PROJECT: Cliff Shadows S Hickam - Update #1

| <b>SUBJECT:</b>                                                            | Drainage Study for:                           | <b>COPIES TO:</b>                                                                                                                                                                        |
|                                                                            | <b>Cliff Shadows &amp; Hickam – Update #1</b> | Triton Engineering                                                                                                                                                                       |

**Subject: Addendum #1 to Update #1 to the TDS for Cliff Shadows & Hickam  
DS5270B**

FIGURE 5

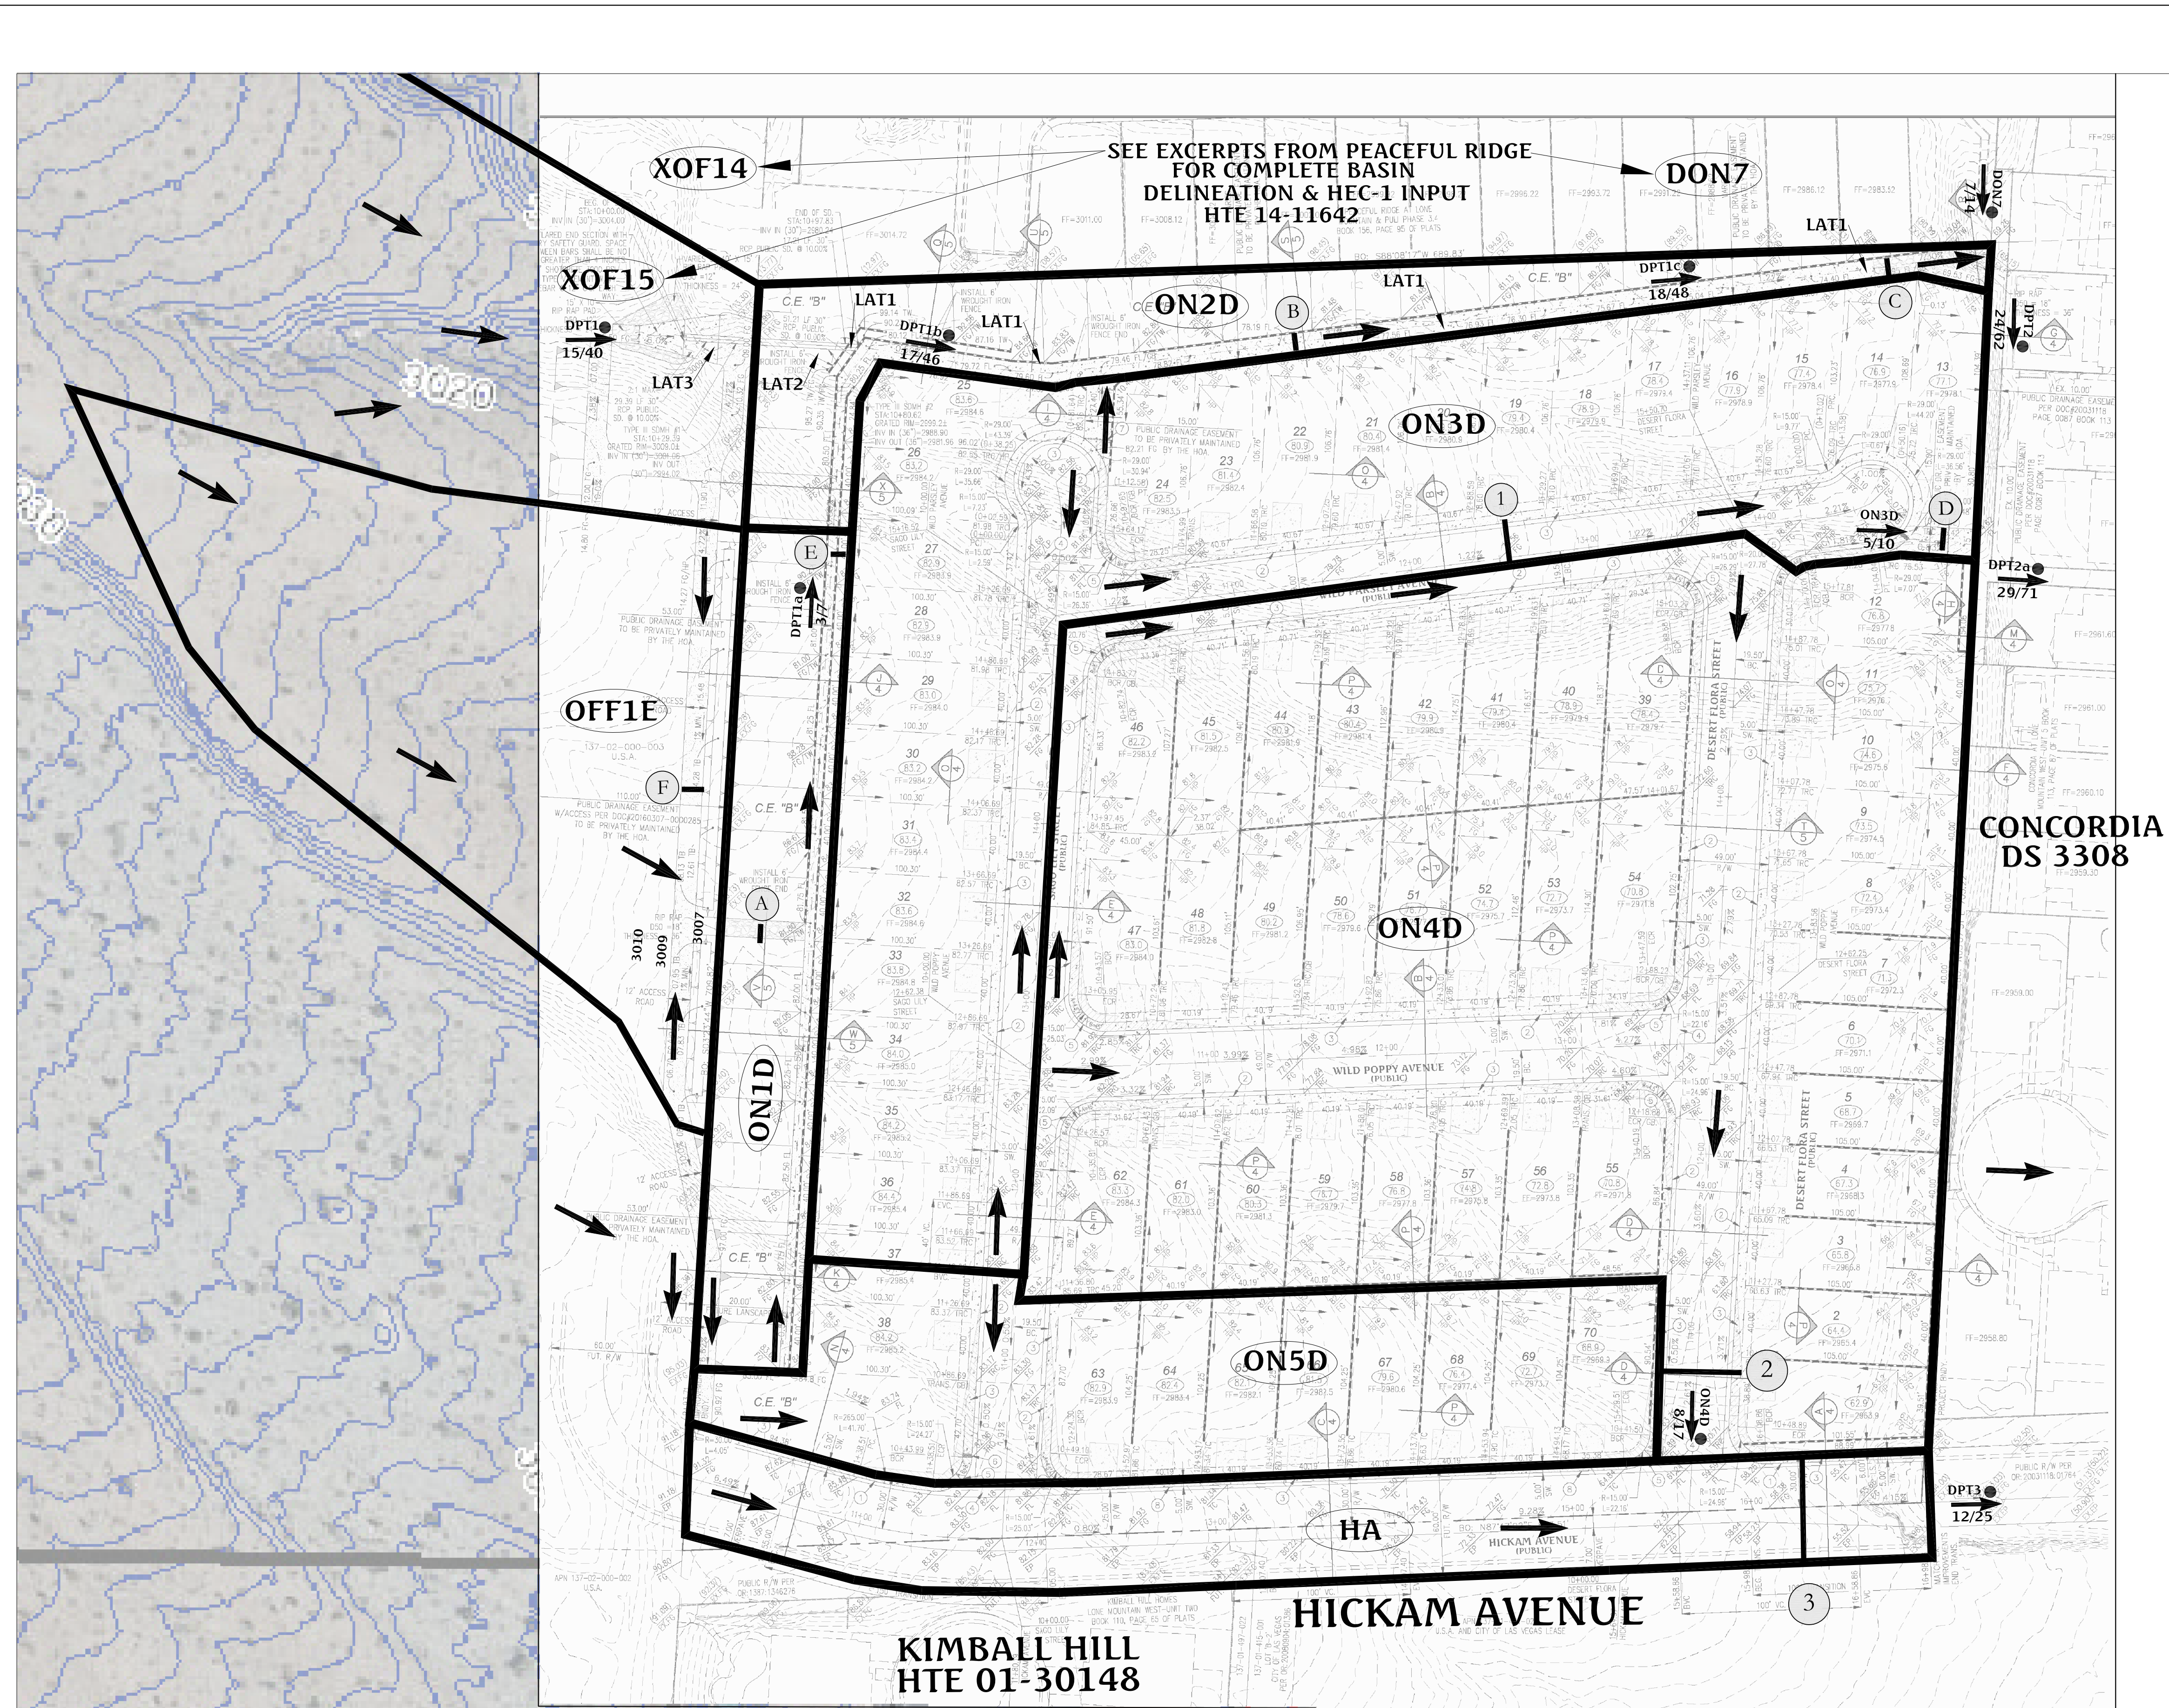
6. Provide a hydraulic section along the western berm to demonstrate the amount of freeboard provided by the berm. Address any erosion mitigation measures if applicable.

Section F has been to the TDS. The hydraulic results are attached, and the results are shown on the revised Figure 4. Please note the velocity is below 5 fps which will not require additional protection.

GRADING PLANS

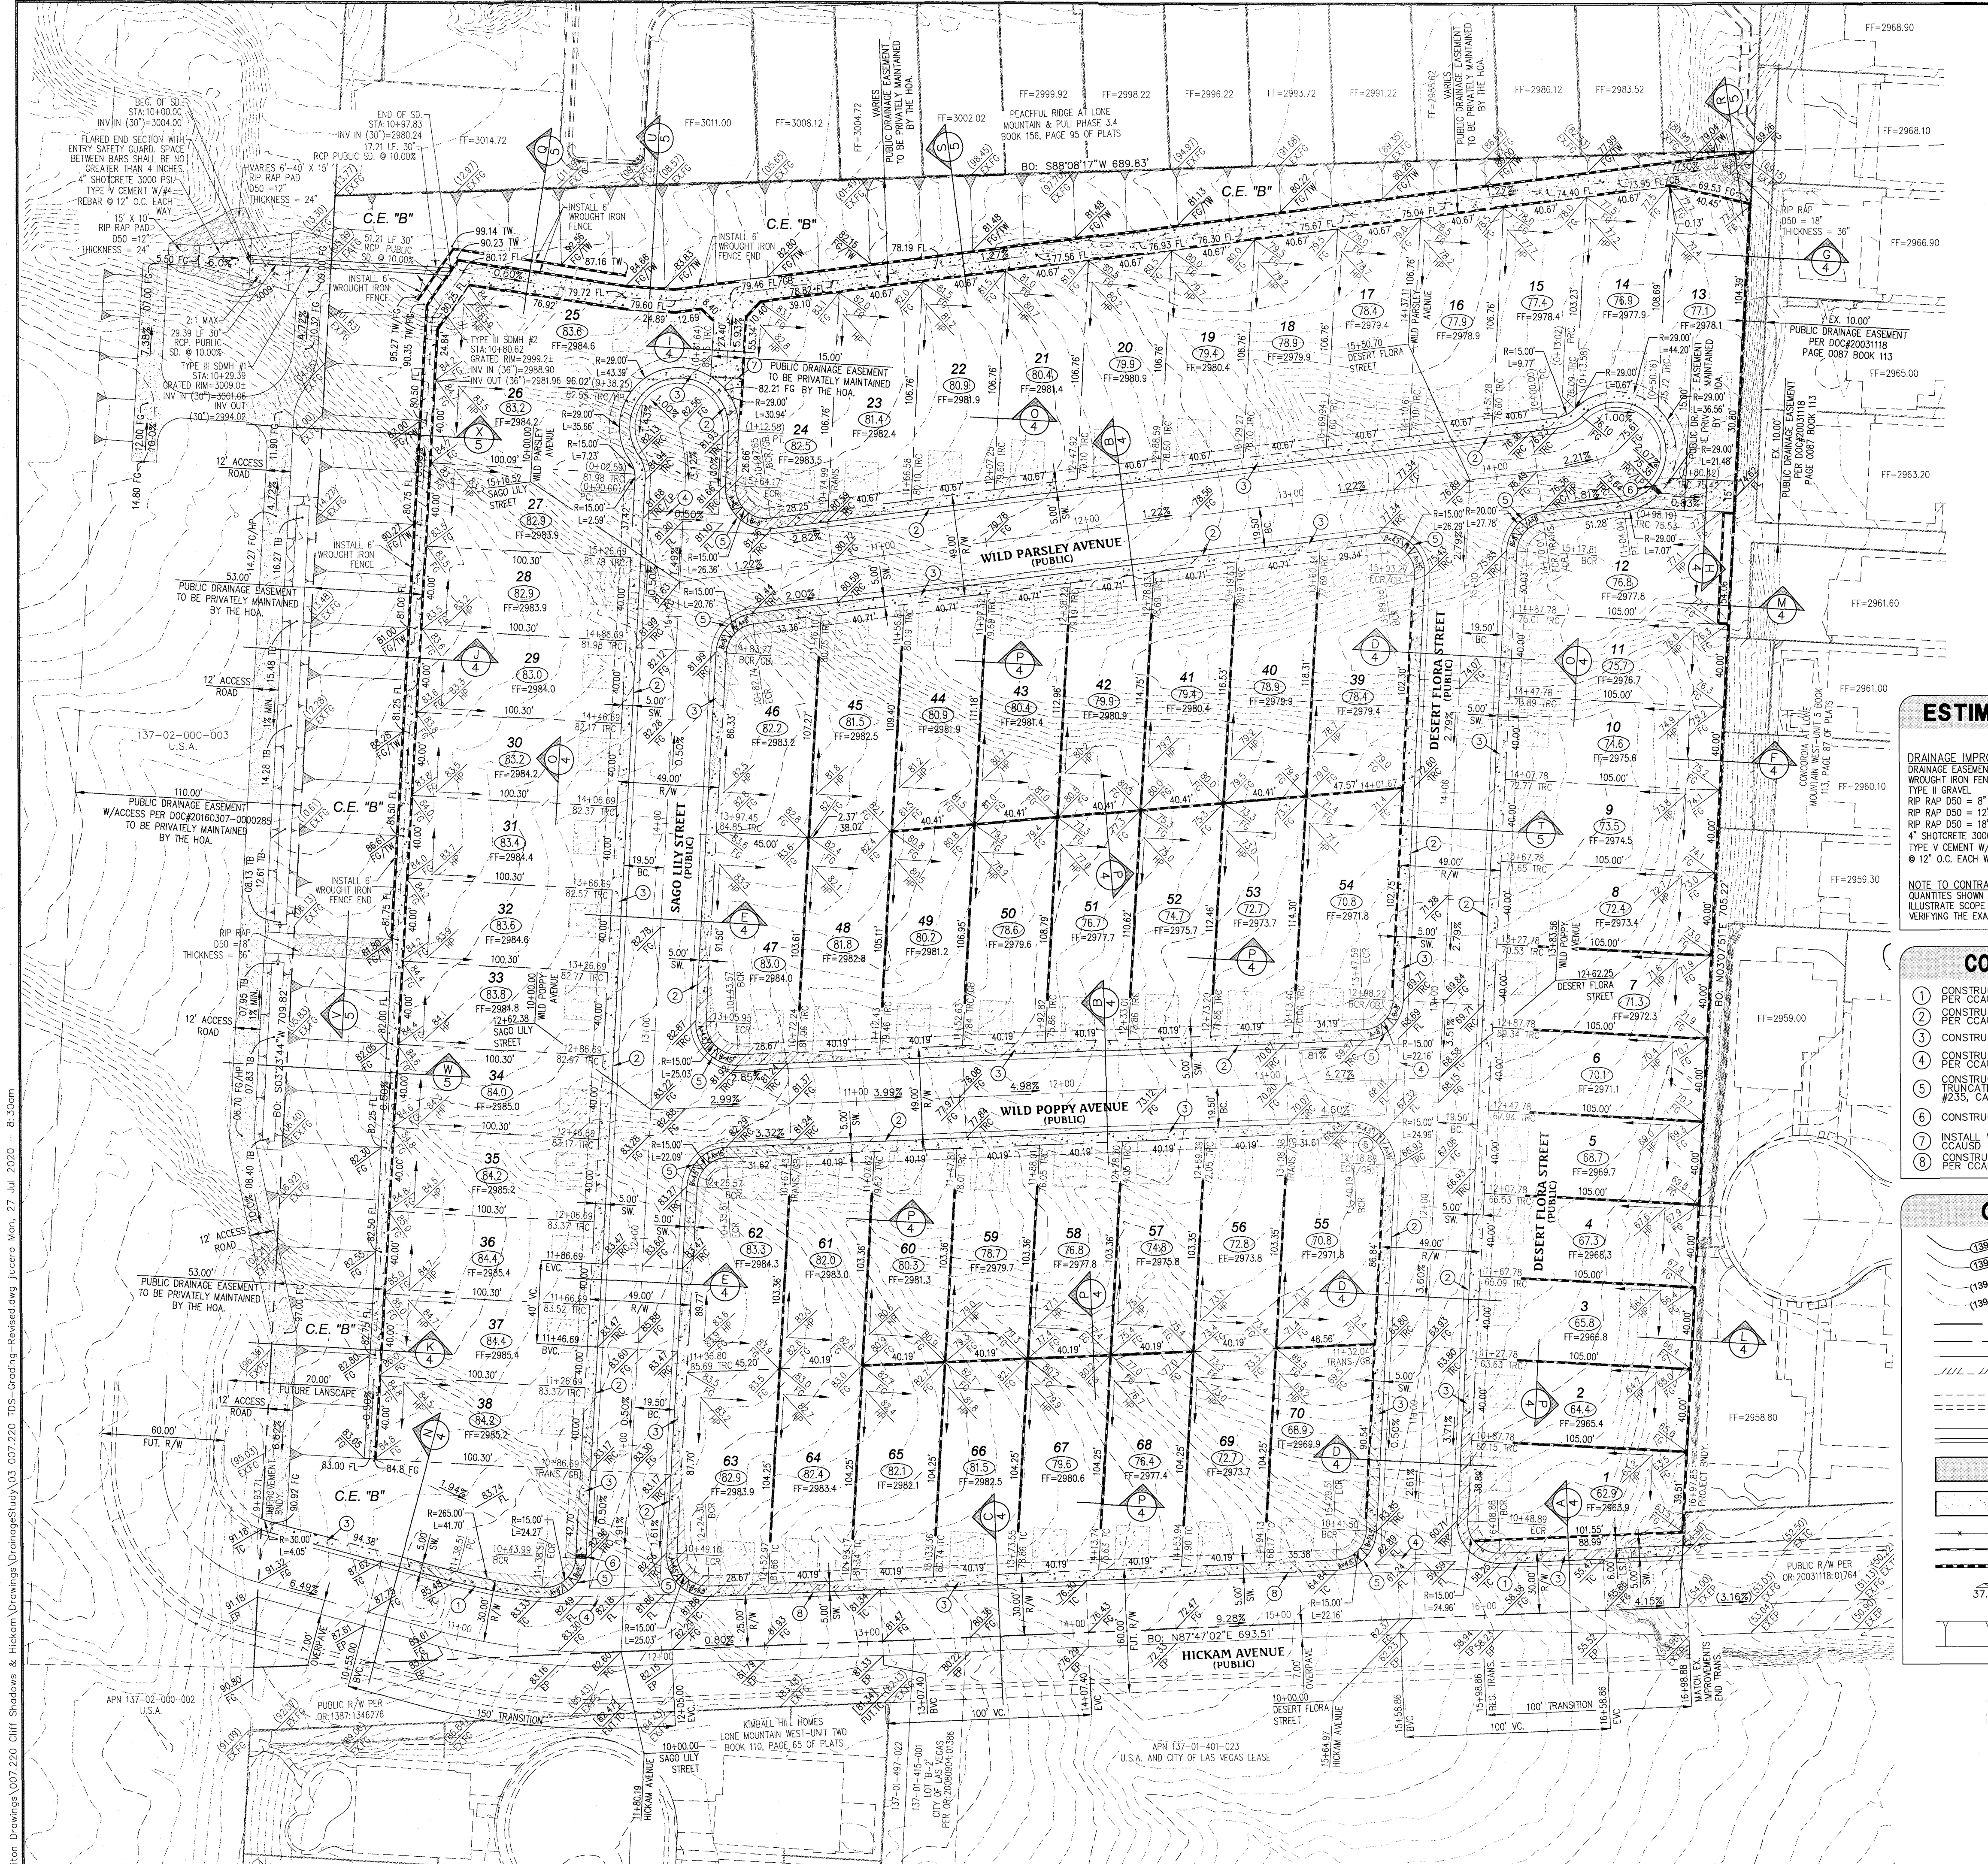
1. Label Document Number or Book and Page Number for all existing easements on the grading plan, including the BLM Grant along the western boundary of the subject site.

1. **Label Document Number or Book and Page Number for all existing easements on the grading plan, including the BLM Grant along the western boundary of the subject site.**

4. Provide a minimum 12-foot access along the berm and to the inlet pipe. Access to all manholes shall also be provided.

Document numbers have been labeled on the grading plan as requested.

A 12-foot access road has been added along the offsite berm and to the inlet pipe and SDMH #1. Access to the onsite SDMH #2 will be from the public drainage easement between lots No. 24 and 25.
